01/11/2023
CAL FTL 54-026

**Subject: Early-Production eCascadia Vehicles
Ordered with Sales Data Code 7AF-002 HV DC Only
Charging Option CCS1 with Dual Port 270kW
Maximum**

**Models Affected: Specific model years 2023-2024 Freightliner
eCascadia vehicles manufactured October 2022 through April
2023.**

Fig. 1, Block-Off Plate Over the Second Charging Port

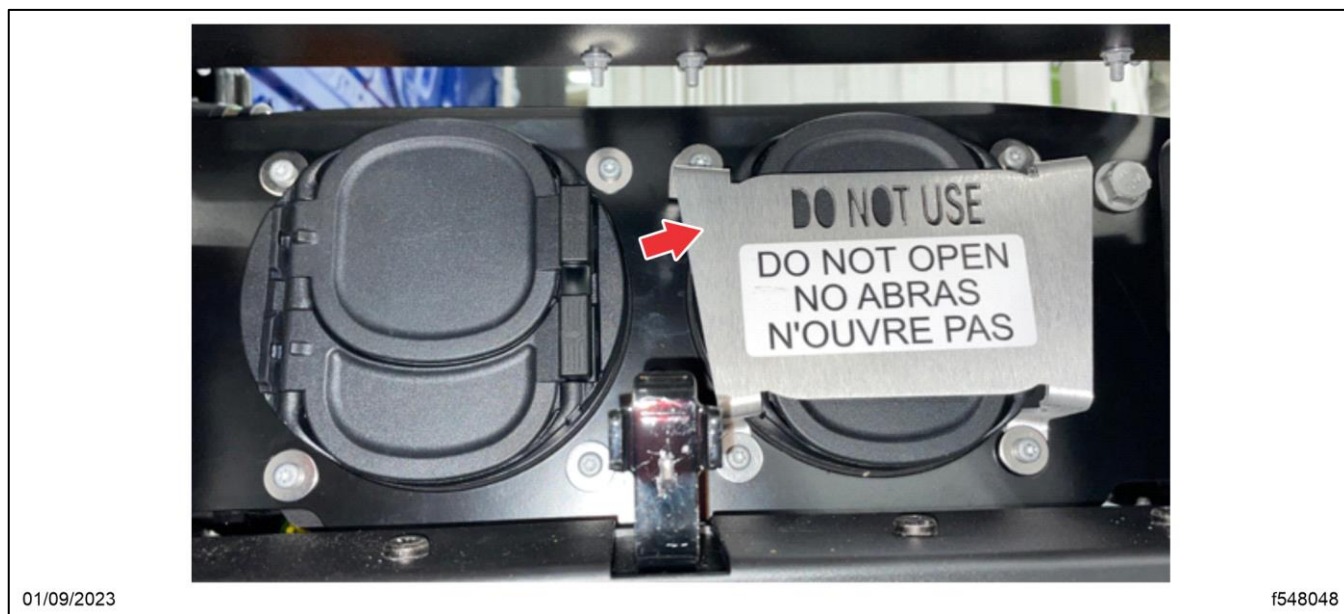
The vehicle(s) are equipped with two charging ports, but the software and hardware required to support dual-port charging is not available yet. The vehicles have a block-off plate that reads 'DO NOT USE,' over the second charging port, as shown in [Fig. 1](#).

When the software and hardware are fully developed, a Field Service Campaign will be issued to update all affected vehicle(s), and enable the dual-port charging functionality. For now, the vehicle will charge normally, at up to 180kW, utilizing only a single charging port.
